**FILE** P.I. # 0007158 **OFFICE** Design Policy & Support  
CSBRG-0007-00(158)  
Banks County  
GDOT District 1 - Gainesville **DATE** March 12, 2013  
SR 63 @ Middle Fork Broad River

**SUBJECT** APPROVED CONCEPT REPORT

**DEPARTMENT OF TRANSPORTATION  
STATE OF GEORGIA  
PROJECT CONCEPT REPORT**

**BY:** Suzanne Dunn  
**DATE:** September 13, 2012- Rev 10/1/12  
**SUBJECT:** Draft Concept Report Review PI#0007158, Banks County

STATE OF GEORGIA  
DEPARTMENT OF TRANSPORTATION  
OFFICE: ROADWAY DESIGN  
**TYPICAL SECTIONS**

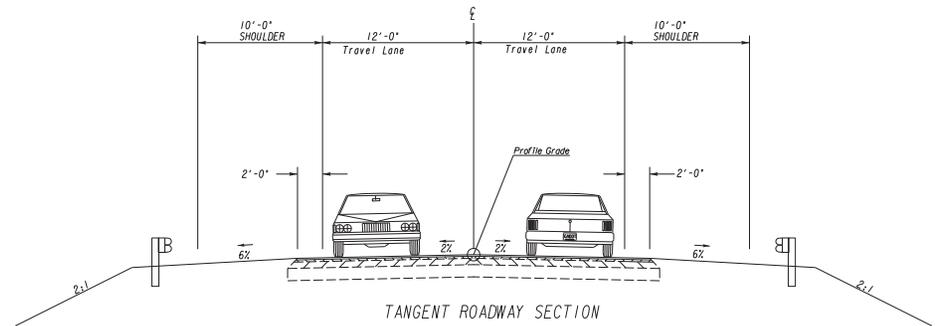
- TCrabtree stated that if a Design Speed of 55 mph is going to be used, that a 10' shoulder with 6.5' paved is required per GDOT DPM Chapter 6, not a 10' shoulder with 2' paved which is what the Concept Report is currently showing. Per AWelch-As this is a bridge replacement project with limited roadway work, the roadway typical section will be removed and the shoulder will taper from the existing shoulder to the bridge shoulder

**ADVANCE WARNING SIGN LOCATIONS**

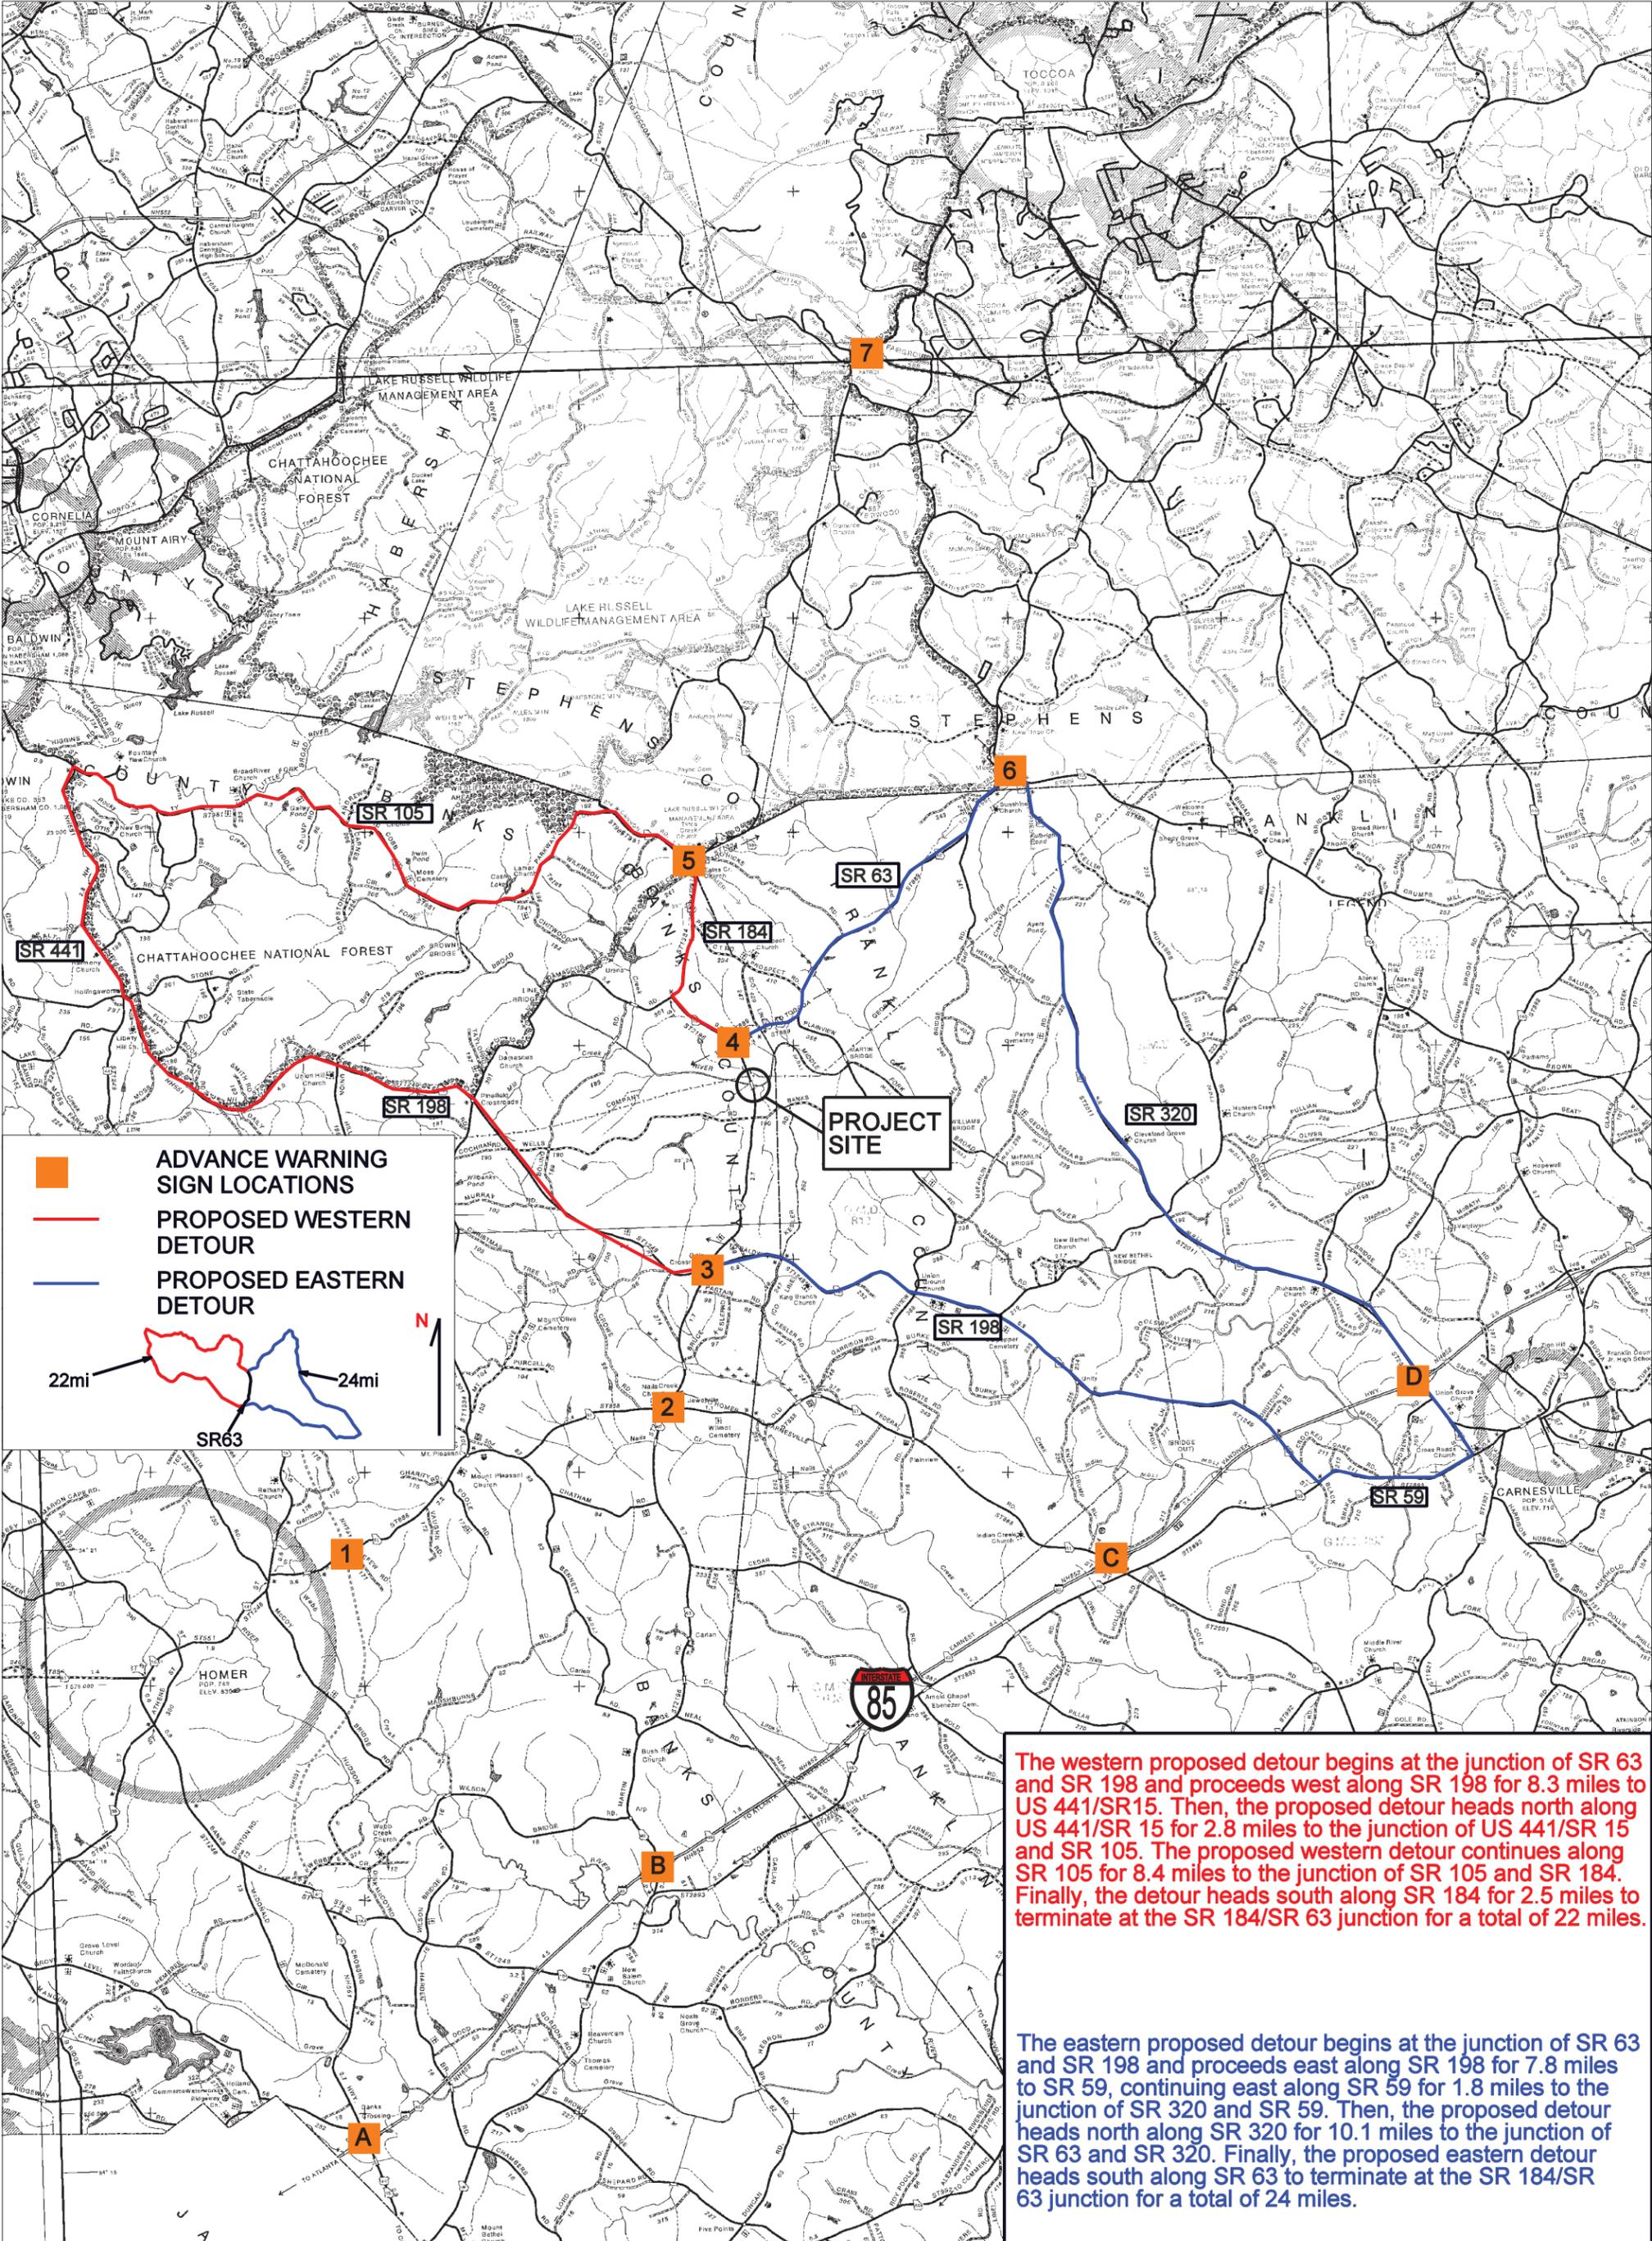
- The potential detour routes were discussed. It was pointed out that the detour map in the report has the distances for the potential eastern detour route backward. The "Alternate Eastern Route" should read 5.0 miles not 7.5 miles and the "Eastern Detour" should read 7.5 miles not 5.0.

- Per AWelch- The detour map will be revised and re-submitted before the Concept Report submission.
